# INSTRUCTION TO SERVICE

ITS61391		DATE:07/09/2025
<b>SECTION:</b>	420 - BODY APPLIED PARTS - EXTERIOR	
<b>SUBJECT:</b>	Retrofit baggage bay door handle mounting bracket.	
<b>ISSUE:</b>	Existing mounting bracket is not compatible with the new door handle assembly.	
<b>SUMMARY:</b>	Replace baggage bay door handle mounting bracket with updated design.

**Figure 3: Door Handle Mounting Bracket Removal**

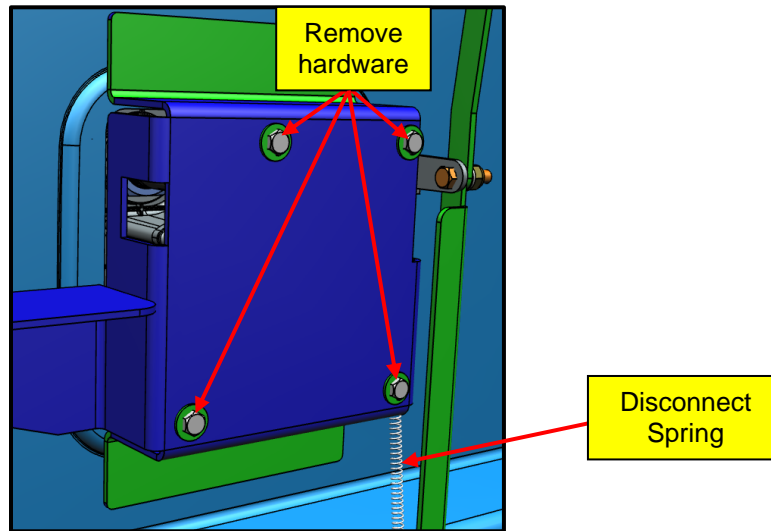
6. Disconnect the spring (part of the door assembly) to the bracket.
7. Remove capscrew (PN: 19-1-387) and flat washer (PN: 19-2-23). Set aside for reinstallation.

**Figure 4: Friction Gaskets Location Reference**

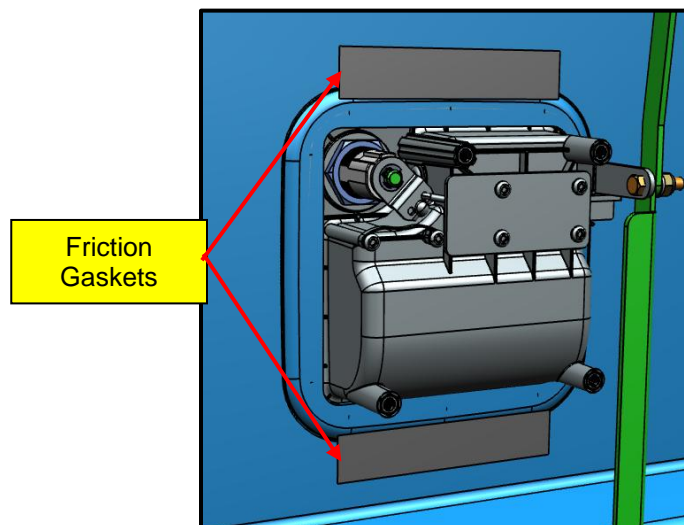
8. Remove existing gaskets and install new friction gaskets (PN: 03-29-1625) between new bracket and inner door panel.

**Figure 5: New Door Handle Mounting Bracket Installation**

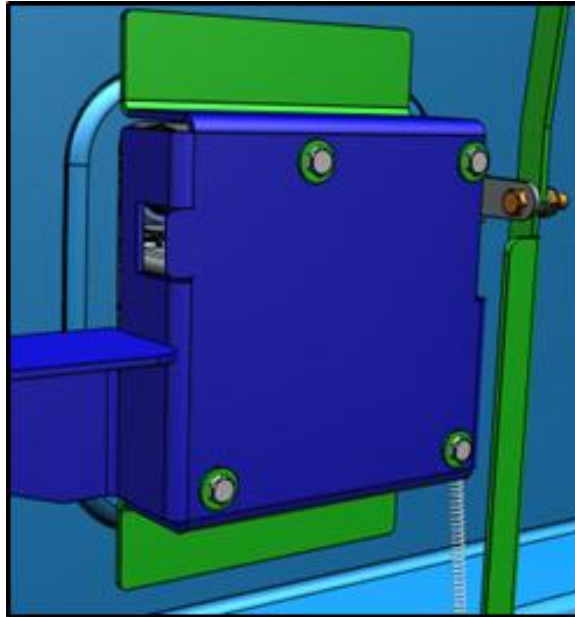
- Install new door handle mounting bracket (PN: 1130599) with existing capscrew (PN: 19-1-387) and flat washer (PN: 19-2-23). Torque to  $10 \pm 1$  in-lbs and apply adhesive loctite (PN: 23-02-0088) to fastener threads before tightening.

**Note: Clean off old loctite before reapplication as necessary.**

**Figure 6a and 6b: Motor Installation on New Bracket**

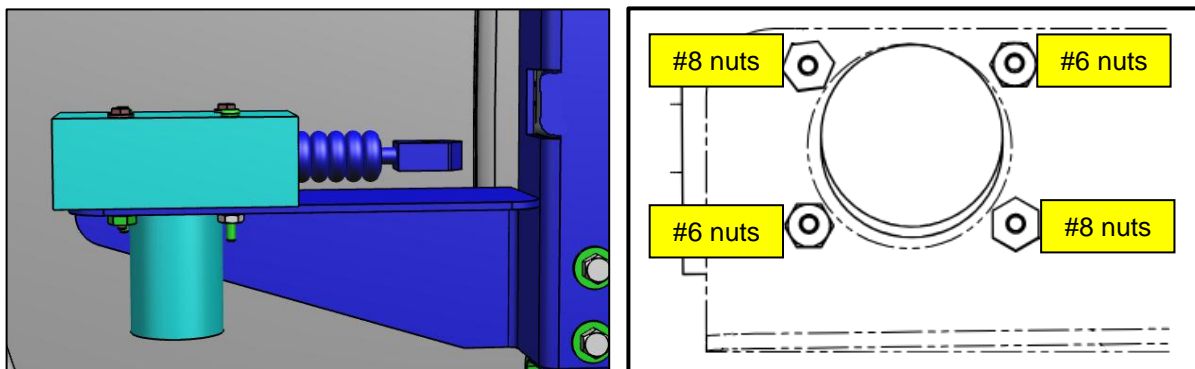
- Reinstall motor (PN: 7L-8-959) with existing screws and nuts from step 5. Torque #6 nuts (19-03-0591) to 14-18 in-lbs and torque #8 nuts (19-3-111) to 18-22 in lbs. Figure 6b shows bottom view of motor and bracket. Apply adhesive-loctite (PN: 21-7212-18) to #8 fastener threads.

**Note: Clean off old loctite before reapplication as necessary.**

**Figure 7: Harness and Solenoid Lock Rod Reinstallation**

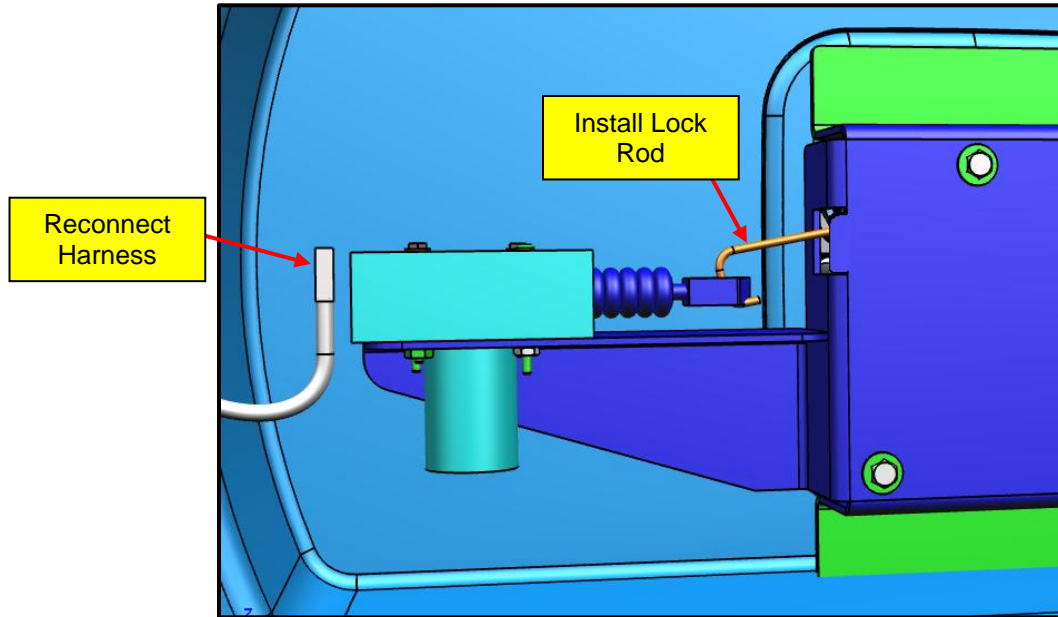
11. Reconnect existing harness (ref PN: 07-12-1018) on the motor. Reinstall lock solenoid rod (PN: 03-29-1570) to motor first, then to the codeable lock handle.
